CITY OF TUALATIN

SUBJECT: Stormwater Master Plan Addendum

Stormwater Master Plan Addendum

Figure 1 Basalt Creek Planning Area and jurisdictional boundaries.

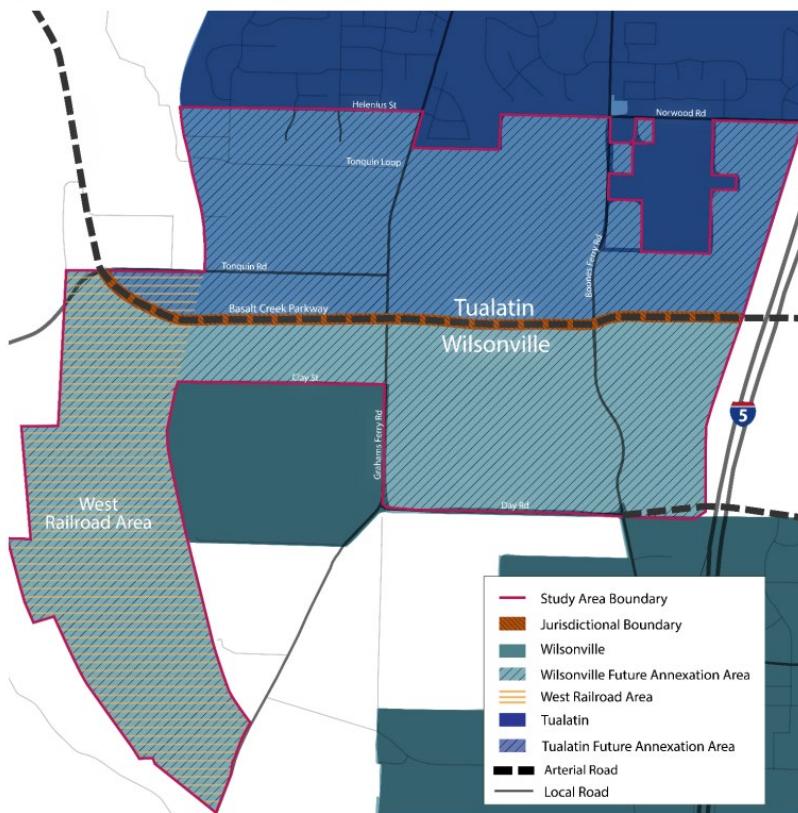
The purpose of this addendum is to provide an analysis of the stormwater basin within the Basalt Creek Planning Area (Figure 1) and to recommend a regulatory approach to stormwater management that would apply to property development in this area.

In April of 2022, city staff conducted field observation of two representative properties in the Basalt Creek area (Alvstead and Mast). At both properties, erosion issues were noted adjacent to the Basalt Creek canyon. At the Alvstead property some sedimentation along the creek due to erosion was also observed. The observed conditions were consistent with conditions shown in aerial photography as well as the existing semi-rural development patterns combined with a lack of existing stormwater infrastructure. Further, as noted in the City of Wilsonville's Stormwater Master Plan, downstream capacity issues exist with the Tapman Creek drainage basin, the upstream portion of which is the Basalt Creek Planning Area. Due to the existing erosion concerns and known downstream capacity issues within the Basalt Creek Planning Area and Tapman Creek drainage basin, city staff have drafted this Stormwater Master Plan Addendum and have proposed a "subbasin" approach for the area.

Therefore, development on all properties in the Basalt Creek Planning Area (Exhibit 1) must meet the following enhanced stormwater management standards:

- Hydromodification, subject to conformance with Clean Water Services' Design & Construction Standards; and
- Construction of permanent on-site stormwater quantity detention facilities designed to meet the 2-year, 10-year, and 25-year storm events.
